DETROIT DIESEL ALLISON COMMERCIAL SERVICE LETTER CSL-1079 RE: HIGH PRESSURE FUEL FILTER (CECO FUEL SYSTEM)

All Model 369H Series Helicopters equipped with CECO Fuel System

SUBJECT: High Pressure Fuel Filter (CECO Fuel System)

H.P. FUEL FILTER ASSEMBLY FIGURE 1

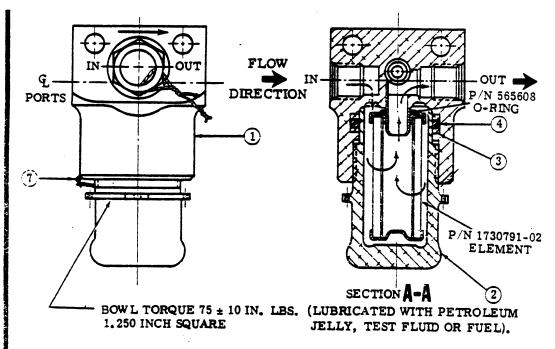
Reports have been received that in-service high-pressure fuel filter elements have bulged and deformed resulting in serious restriction of fuel flow.

This is caused by incorrect filter assembly installation allowing the fuel flow from the fuel pump to enter the filter through the "OUT" port and flow to the inside of the filter element. This reverse flow can oulge the element and in extreme cases severely limit fuel flow.

INCORRECT FILTER INSTALLATION CAN RESULT IN SERIOUS RESTRICTION OF FUEL FLOW OR FLAME OUT. ENSURE THAT FILTER ASSEMBLY IS INSTALLED WITH THE FUEL PUMP OUTLET PRESSURE CONNECTED TO THE FILTER "IN" PORT AND THE FILTER "OUT" PORT IS CONNECTED TO THE FUEL CONTROL ASSEMBLY. CORRECT FILTER FLOW DIRECTION IS INDICATED BY THE ARROW ON THE FILTER HEAD ASSEMBLY. REFER TO FIGURE 1.

All operators are urged to inspect the high pressure filter assembly for proper installation:

- Ensure that fuel pump outlet flow is connected to the filter assembly "IN" port.
- Ensure that the filter assembly "OUT" port is connected to the fuel control assembly.
- Correct filter flow direction is indicated by the arrow on the filter head assembly.
- Observe inlet "IN" and outlet "OUT" markings by removal of mounting bracket where necessary.
